April 28, 2023

RE: DB22-0010 Charbonneau Marina Modifications Response to Letter of Incomplete Application.

Pioneer Project No.: 999-146.7

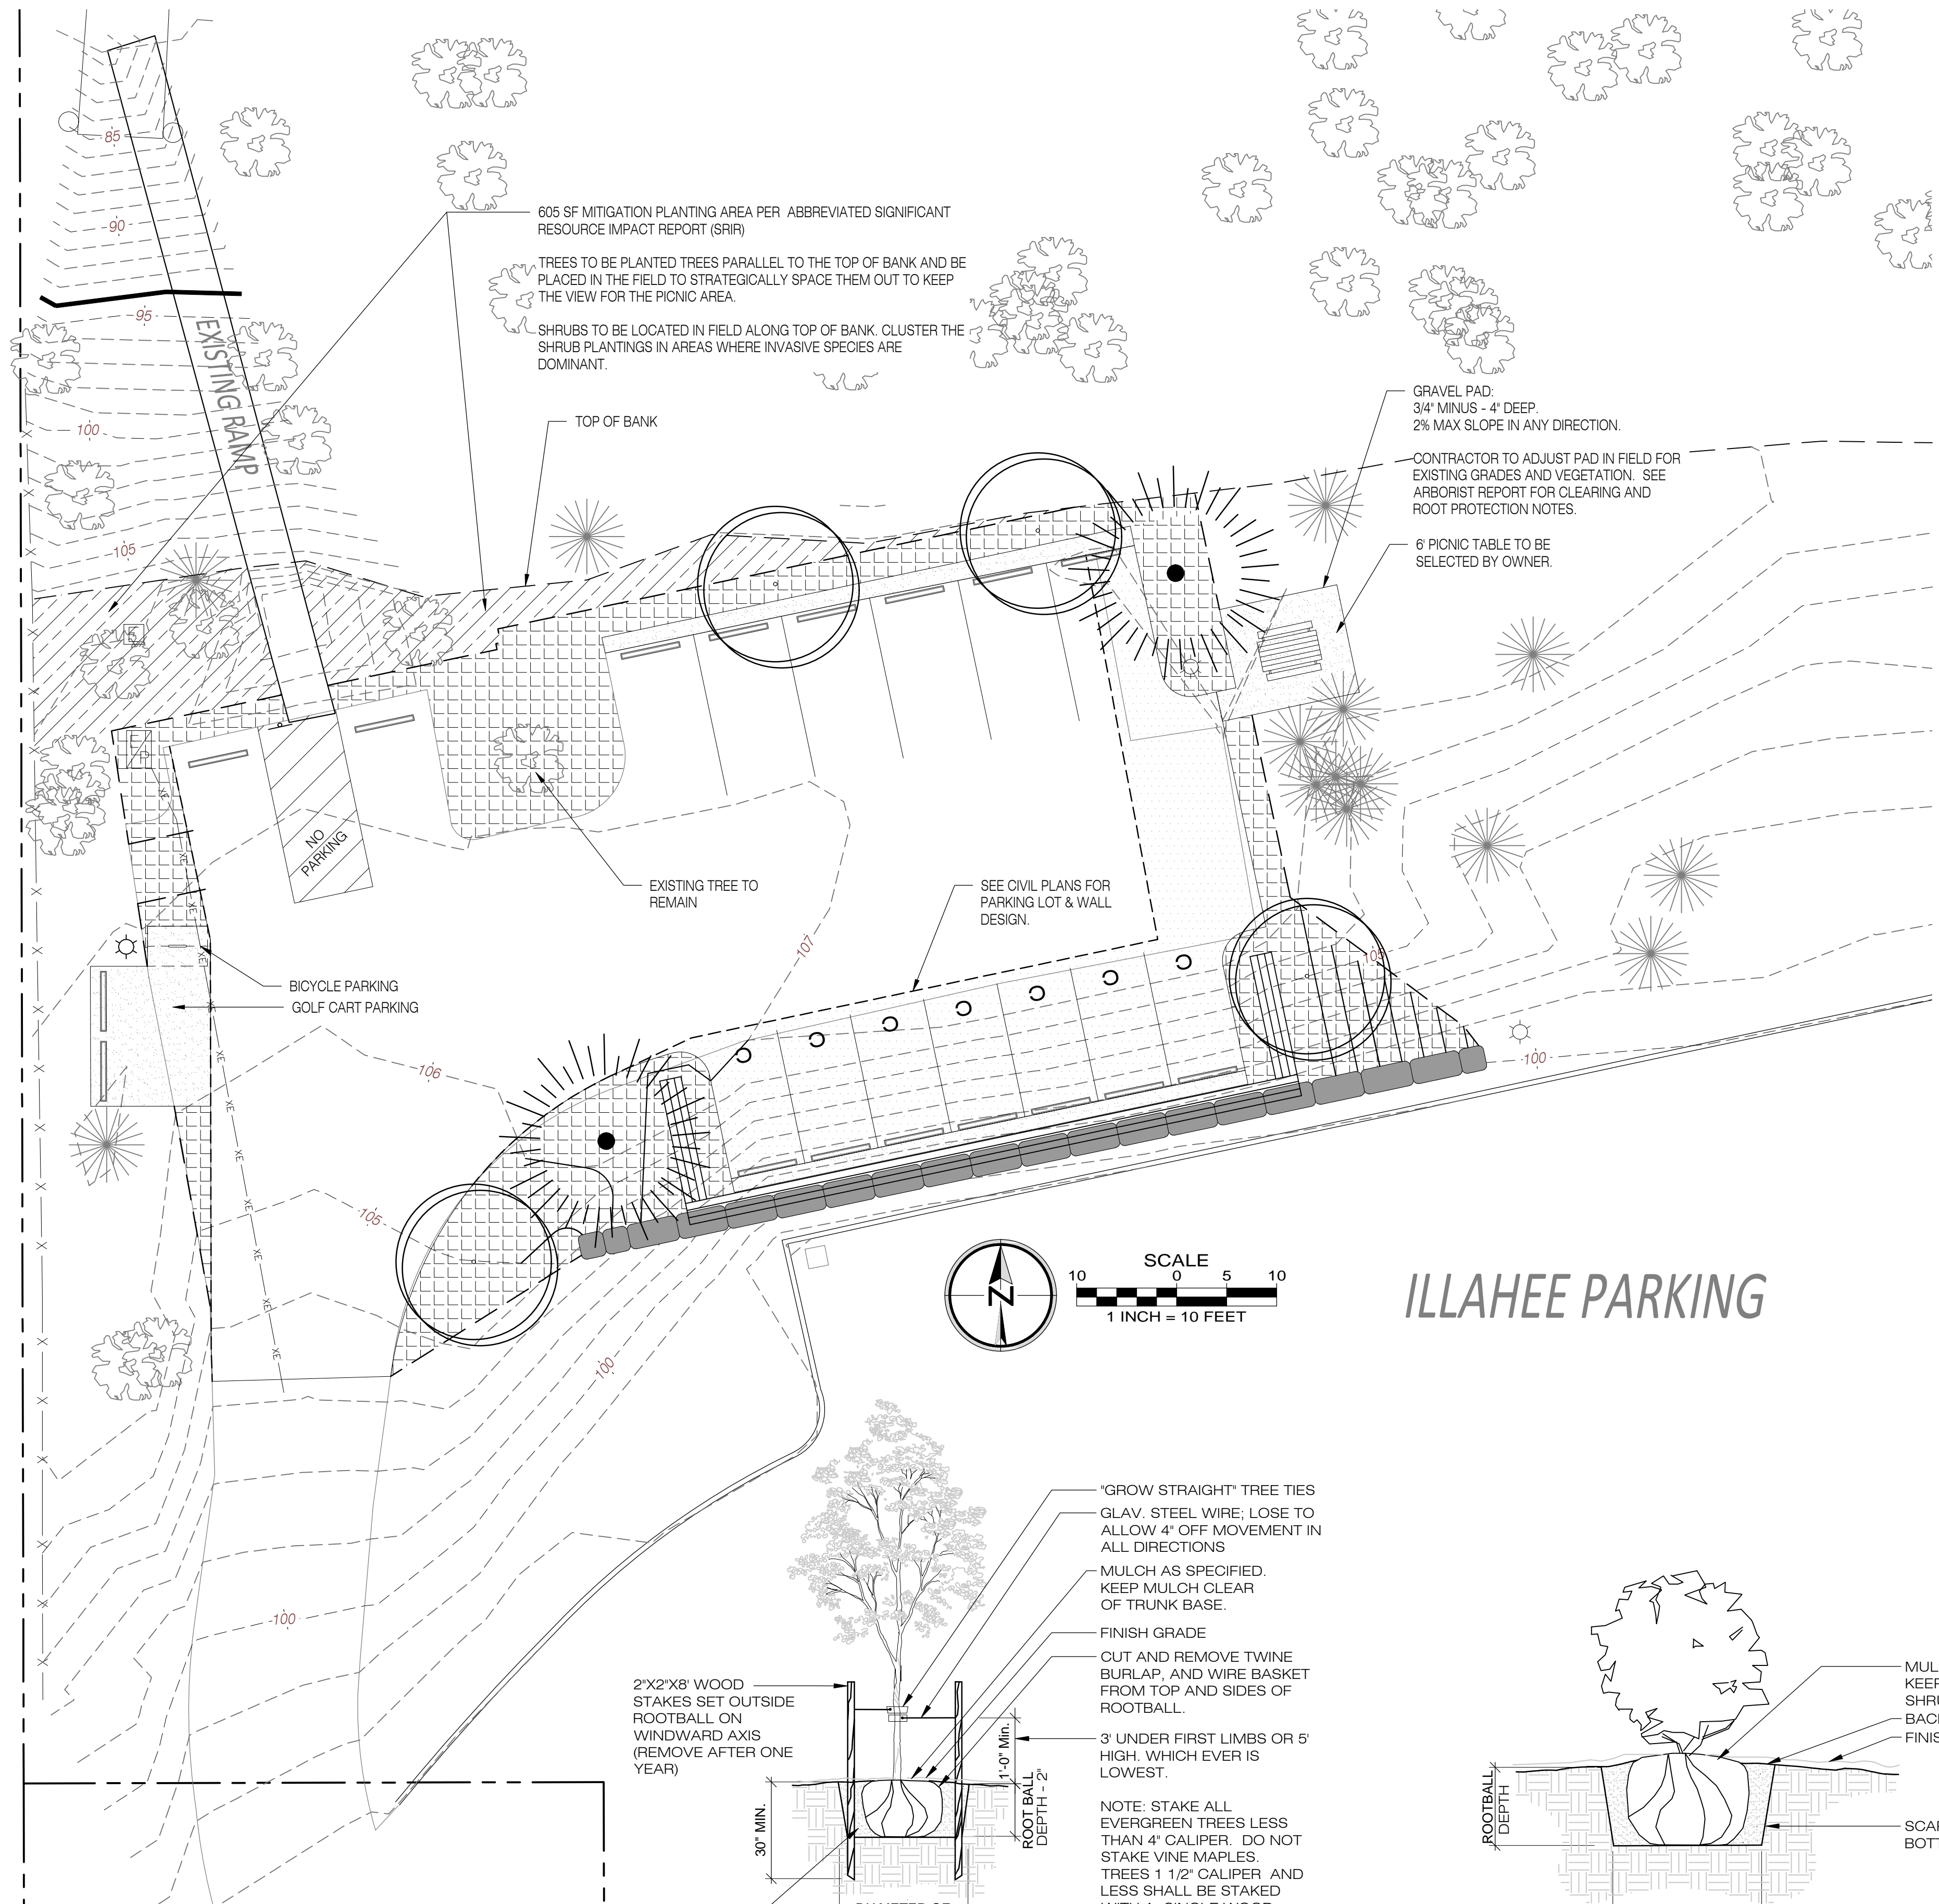
*✦ L1.0, Landscape Plan*

- o Show location of all existing trees proposed for retention*
- o Show areas proposed for mitigation plantings, including proposed trees*
- o Show required parking lot trees and proposed landscaping*
- o Show proposed parking lot improvements*

**RESPONSE:** The updated Plan Set includes a detailed Landscaping Plan, which includes tree mitigation and parking area improvements, including tree island.
